SOMBRE del OSO Apartments

CONCEPTUAL DRAINAGE PLAN

CITY OF ALBUQUERQUE MUNICIPAL DEVELOPMENT DEPARTMENT ENGINEERING DIVISION					
TITLE: SOMBRA DEL OSO APARTMENTS EROSION CONTROL PLAN					
APPROVALS	ENGINEER	DATE	APPROVALS	ENGINEER	DATE
CITY Engineer			Liquid Waste		
A.C.E.-Design			Traffic		
A.C.E.-Hydrology			Water		
DRAWING NO.	MAP NO. E-12-Z		SHEET 5 OF 9

SOMBRA DEL OSO APARTMENTS				SHEET
ADDENDUM NO.1				2
GARDNER, MASON & ASSOC. ALBUQUERQUE, NEW MEXICO				OF
				5
PROJECT NO.	DRAWN: MY+BG	CHECKED: GG	DATE: 5-22-86	SCALE: AS SHOWN
TRACED:	APPROVED:

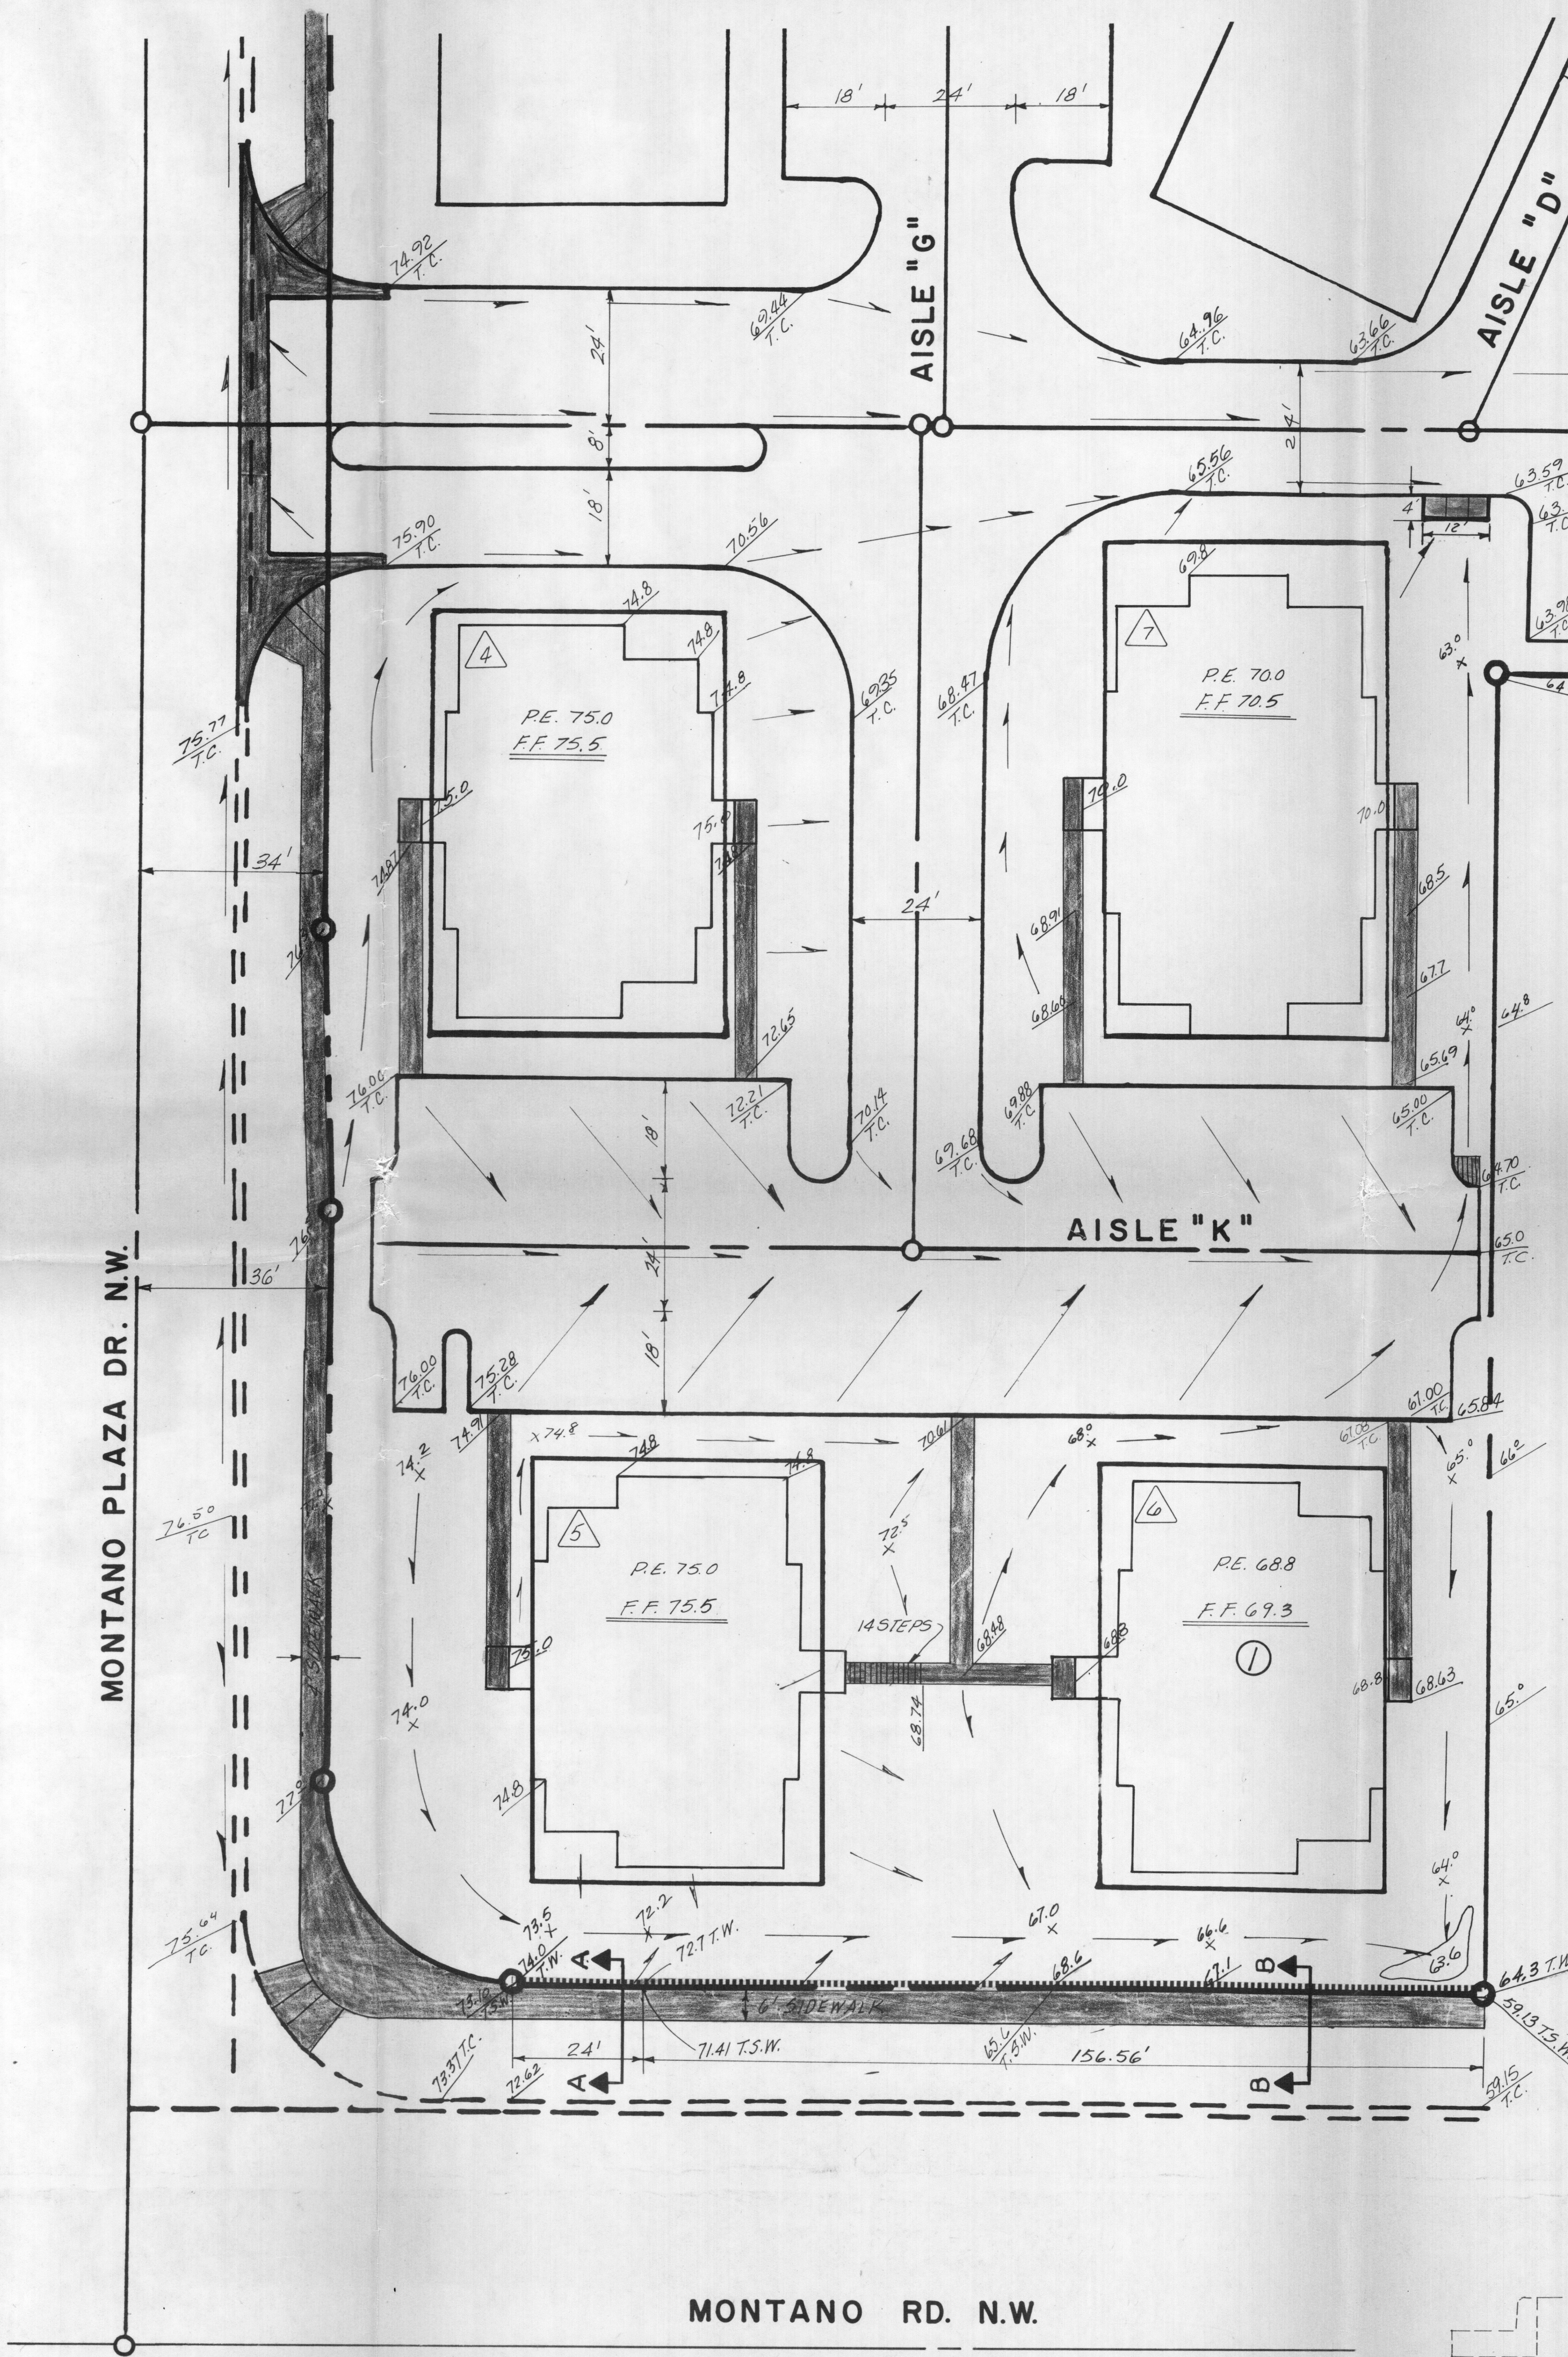
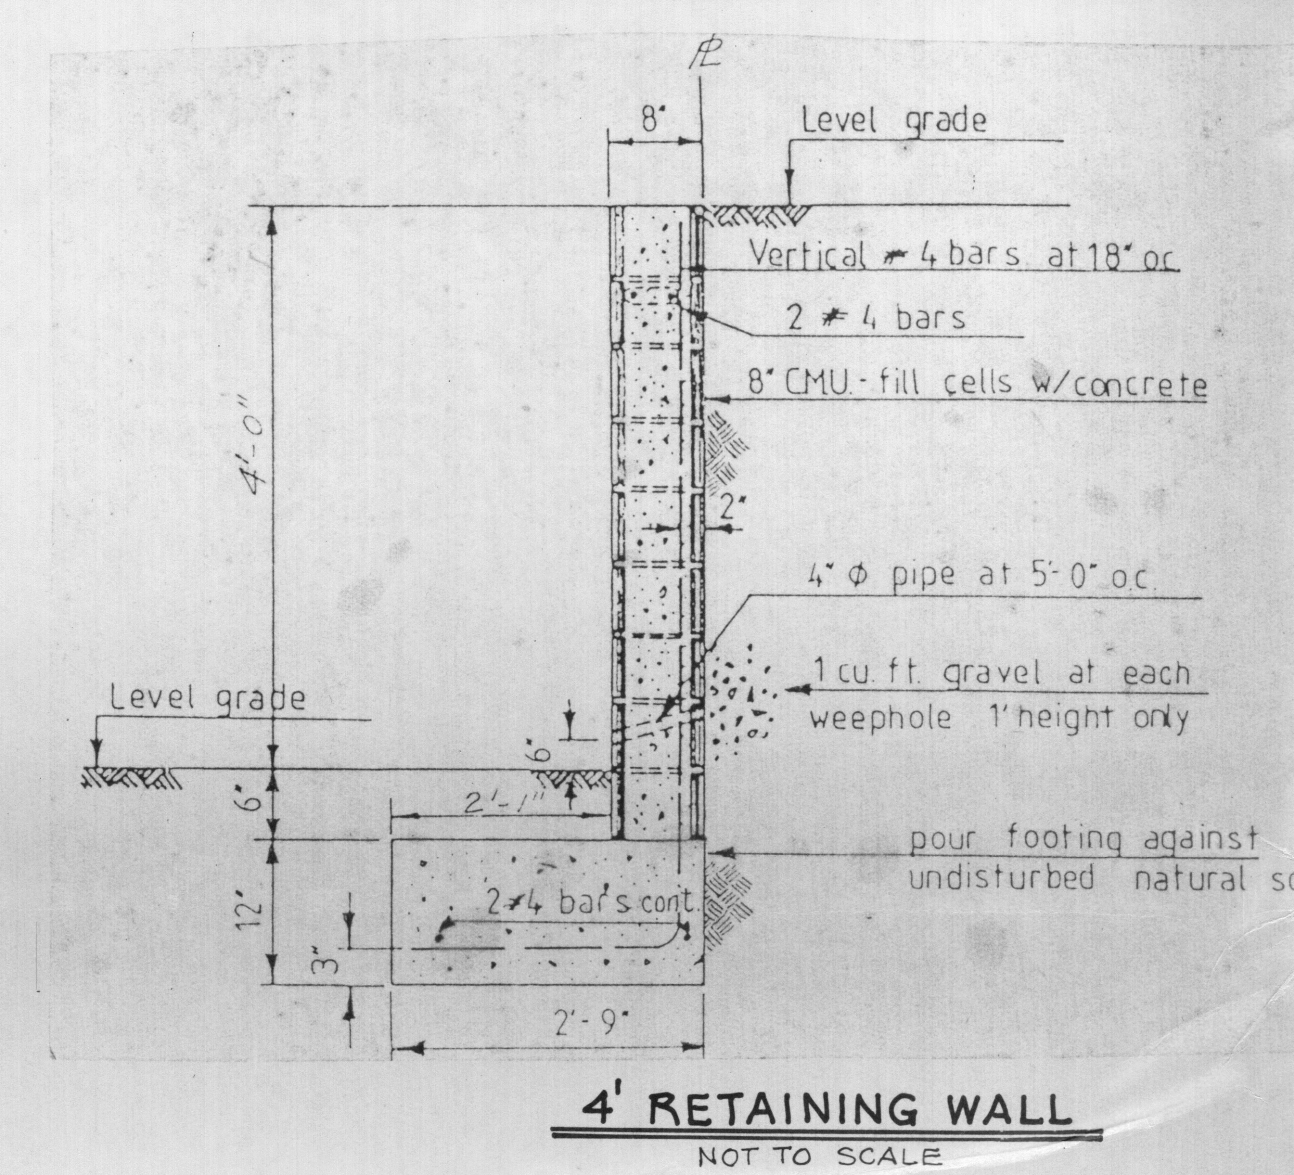
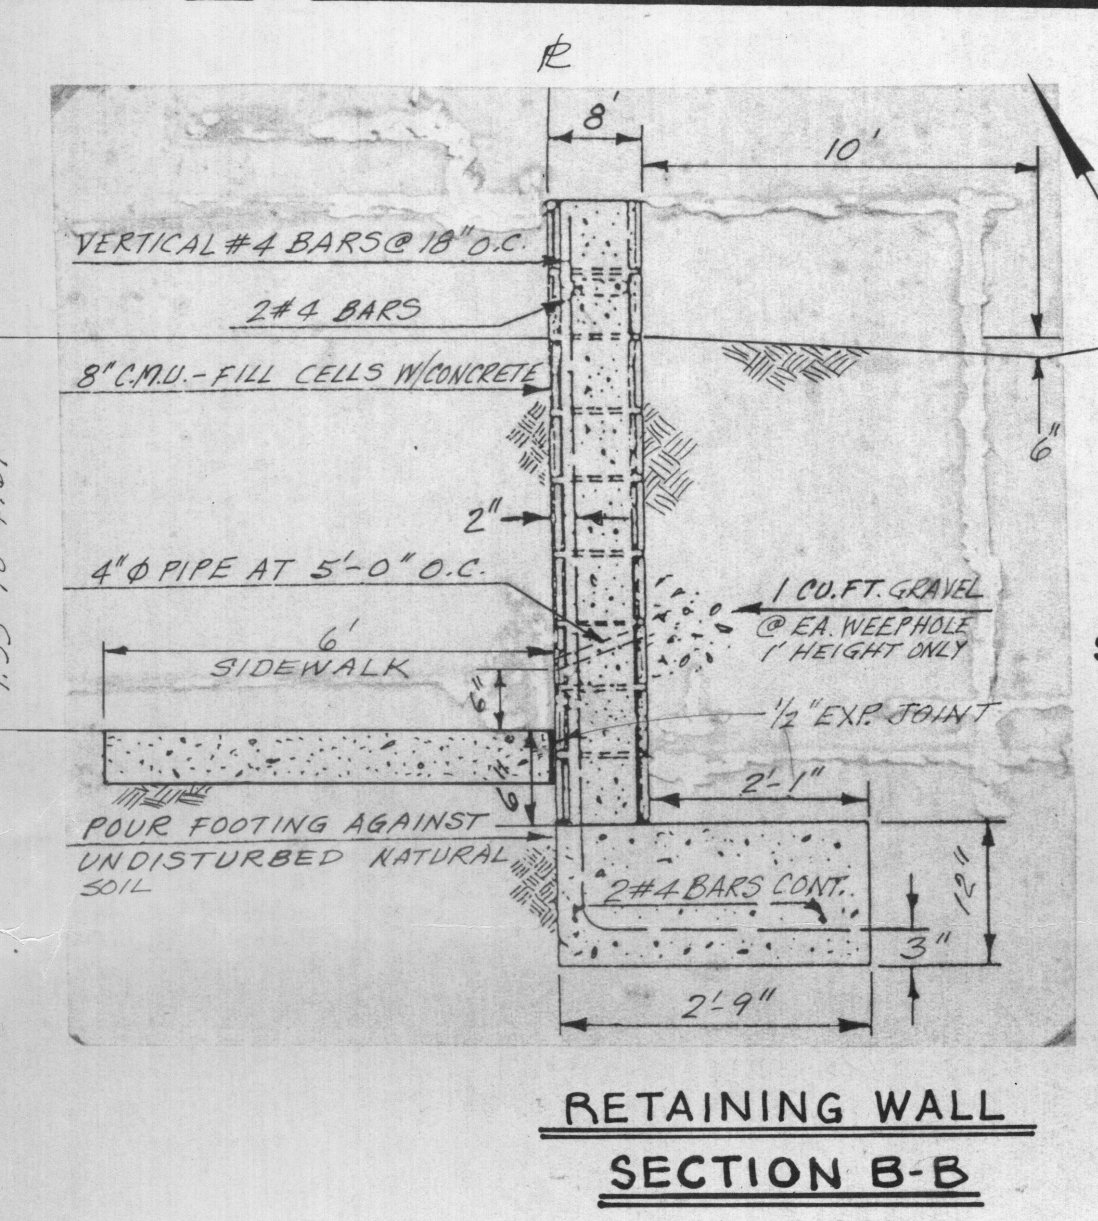
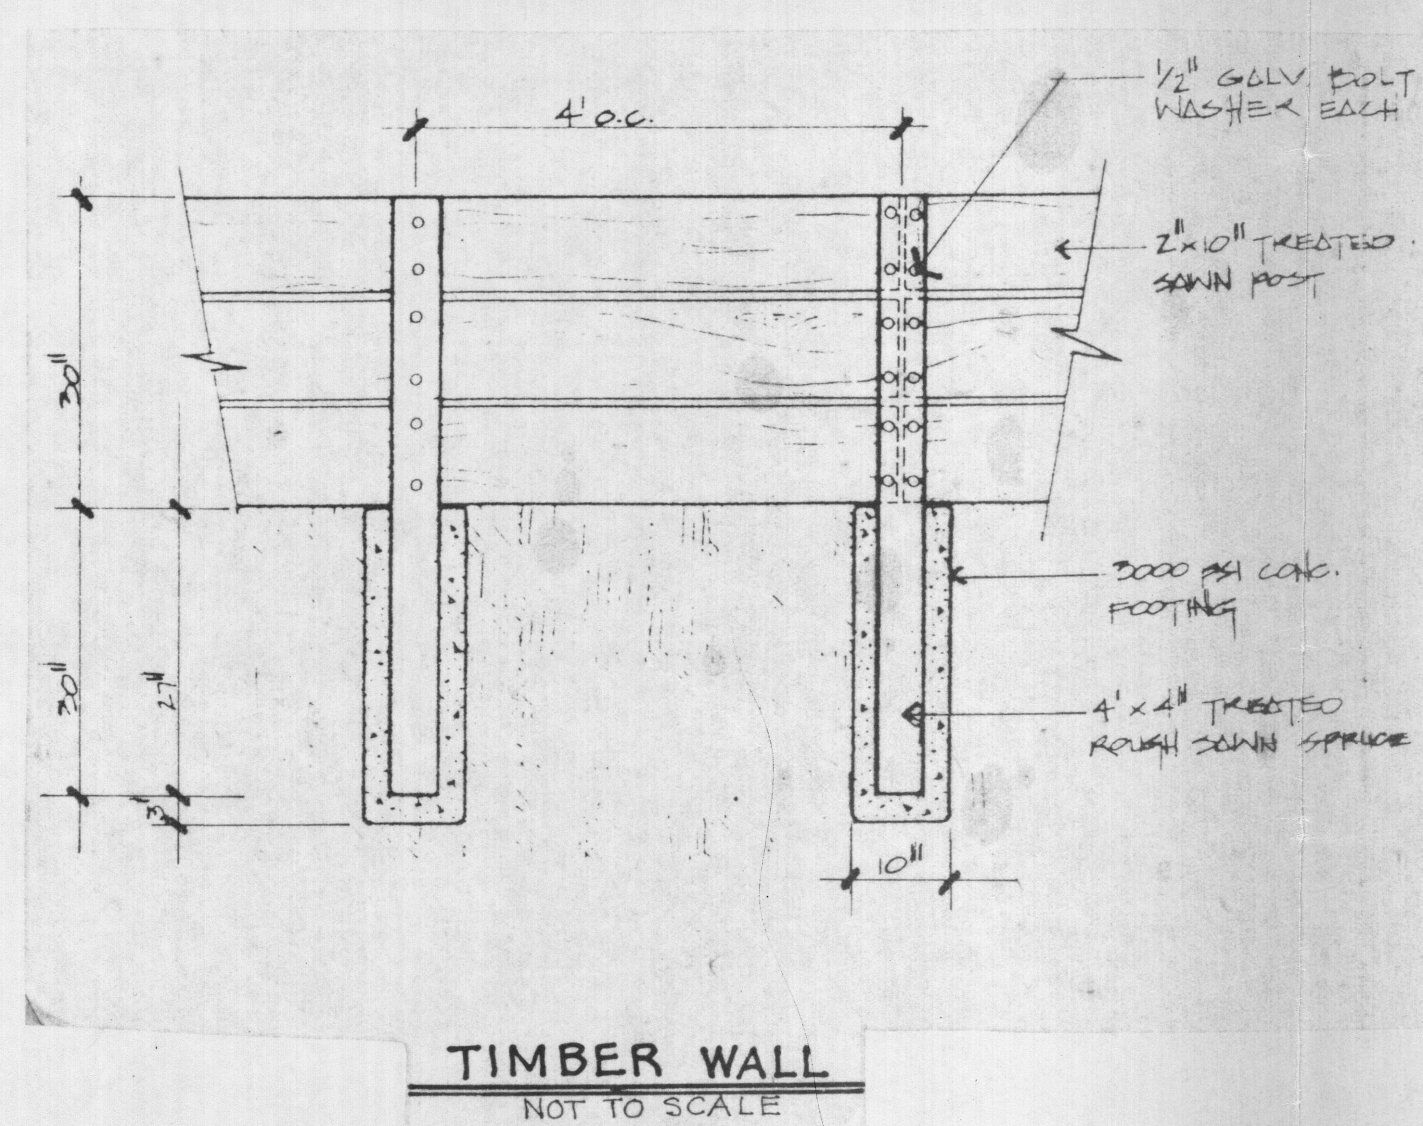
REVISIONS:
 ① BUILDING PAD NO. ① HAS BEEN REVISED TO MATCH AS-BUILT PAD 6/18/86
